Architectural Review
and Historic Preservation Board
Agenda Report

Meeting Date 09/15/21

RE: BCM Construction on Morrow Lane, 3731 Morrow Lane, APN 040-030-046
Southwest Corner of Morrow Lane at Comanche Court in Southeast Chico

File : AR 21-01

Proposed Site Plan

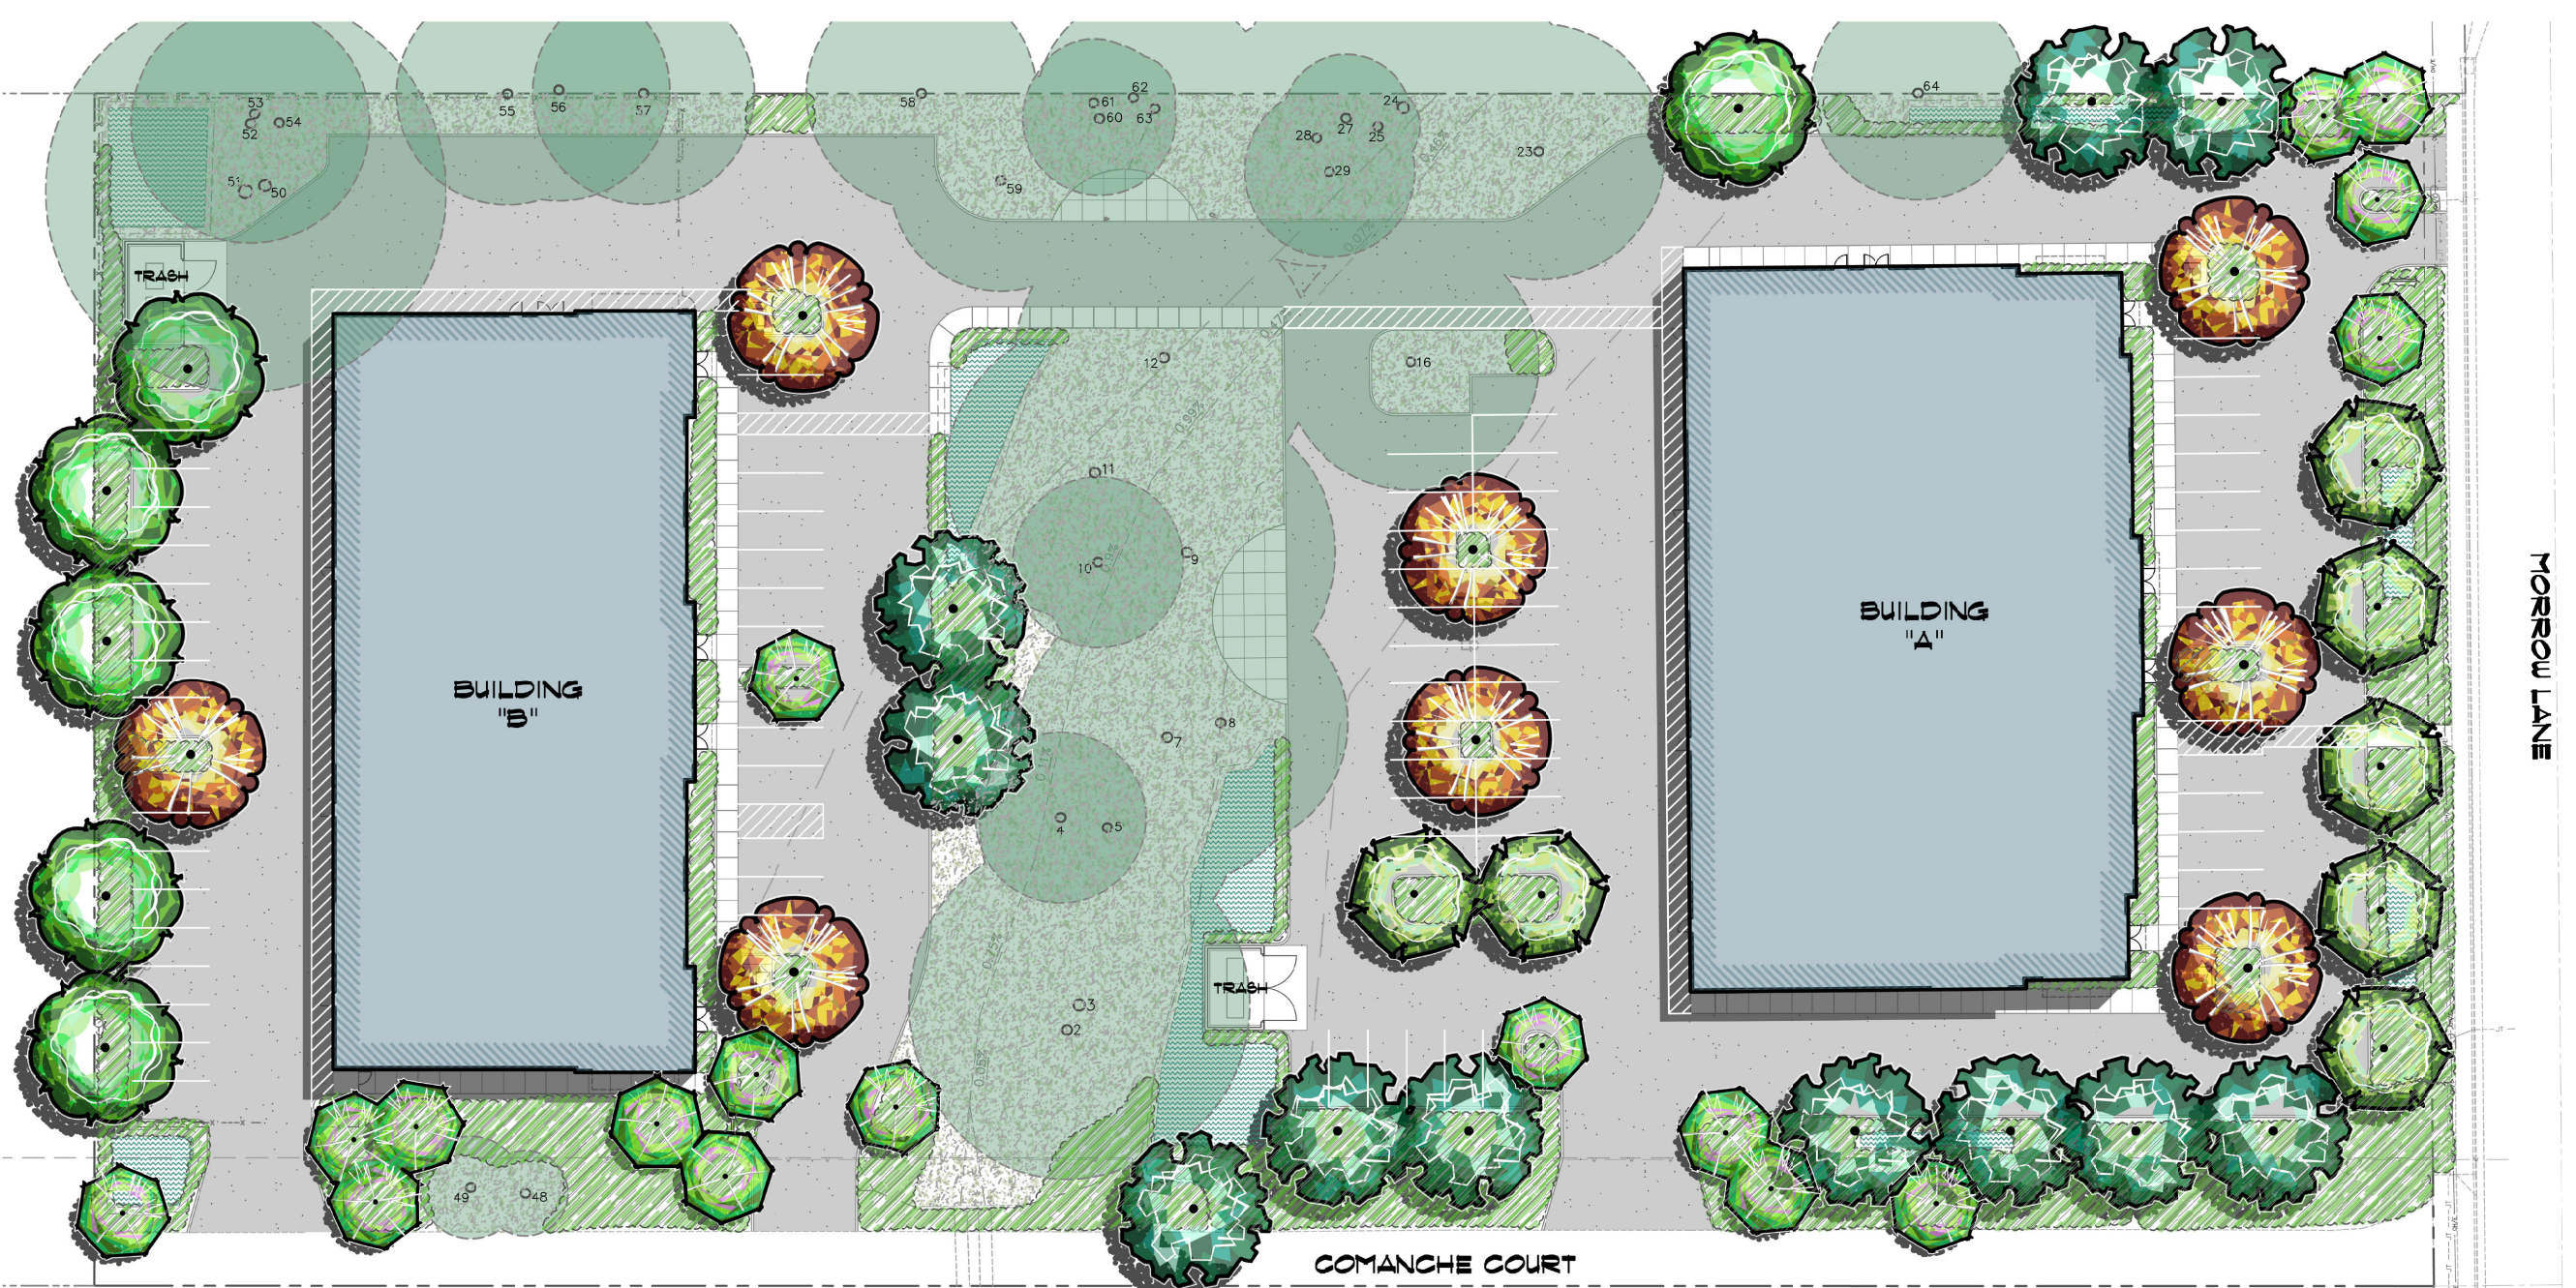
To enhance the success of new tree plantings, recommended Condition #3 would require enlarging the two smallest parking lot island planters from approximately eight feet by nine feet

to eight feet by 18 feet, or otherwise doubling their size to increase soil surface area around new parking lot shade trees. Also, to maximize the likelihood of survival of existing trees to remain, Condition #4 would require preparation of a tree protection plan that would specify the appropriate precautions during construction activities and the final disposition of these trees following construction.

3. Enlarge the two 8-ft by 9-ft interior parking lot planters to be at least 8-ft by 18-ft, or otherwise double their size to increase soil surface area around new parking lot shade trees.

Elevations – Building B

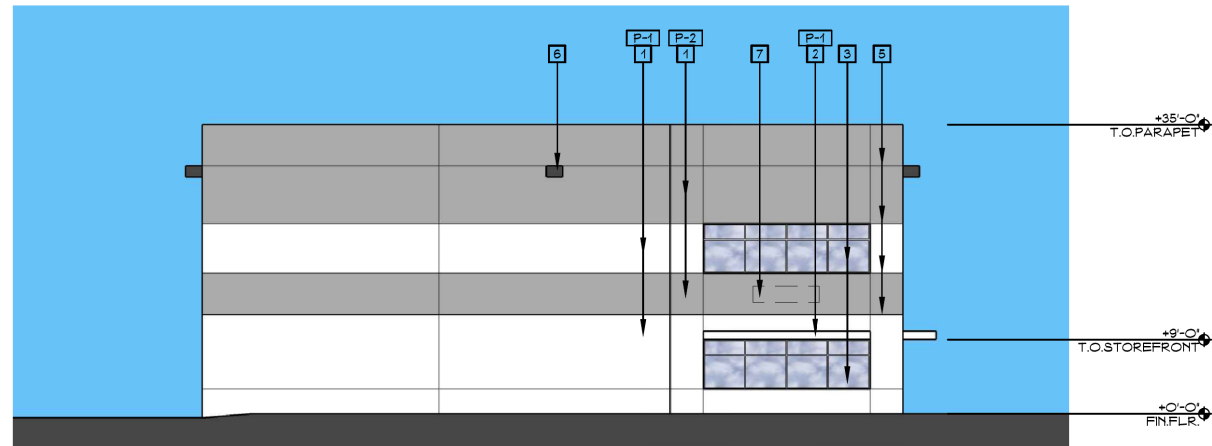
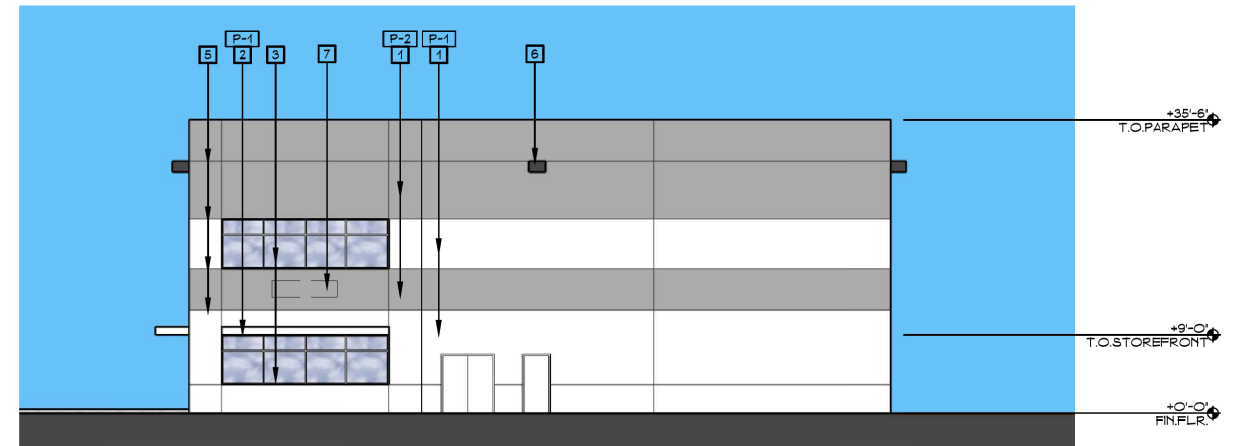
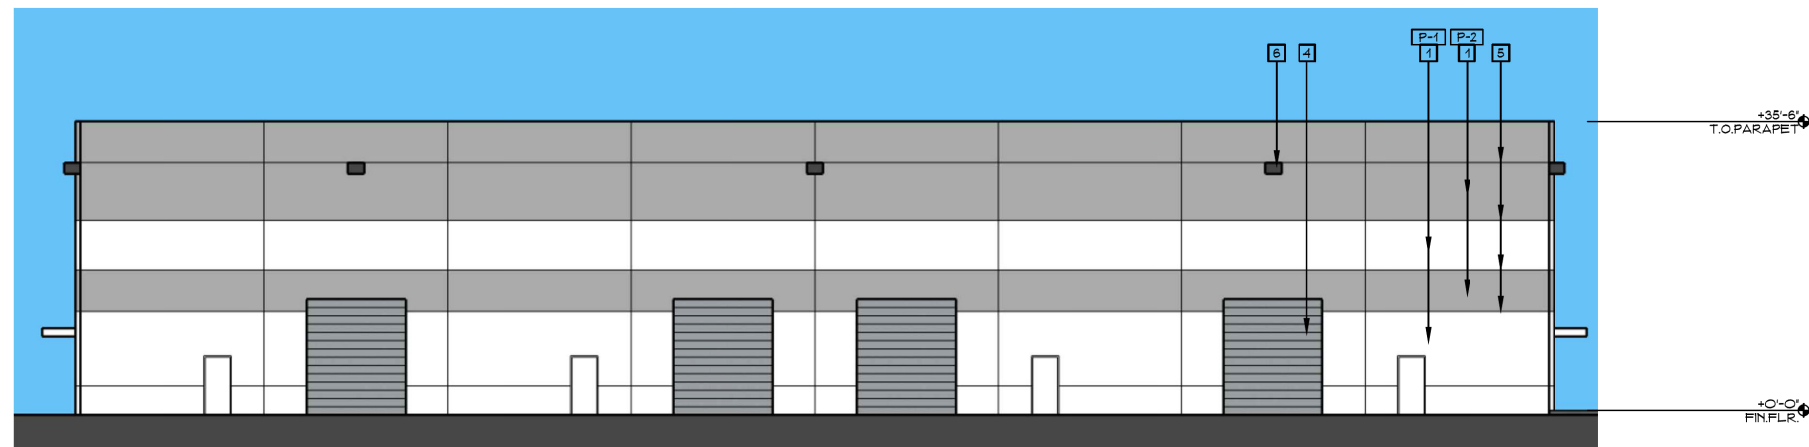
5. MITIGATION MEASURE AES-1 (Aesthetics): Prior to issuance of building permits for Building B the developer shall either (a) replace the single wall-mounted light proposed at 22 feet in height on the easterly end of Building B with two or more similar lights mounted no more than 12 feet above finished grade, or (b) revise the photometric plan to demonstrate that no more than 0.5 footcandles would shine past the centerline of Comanche Court.
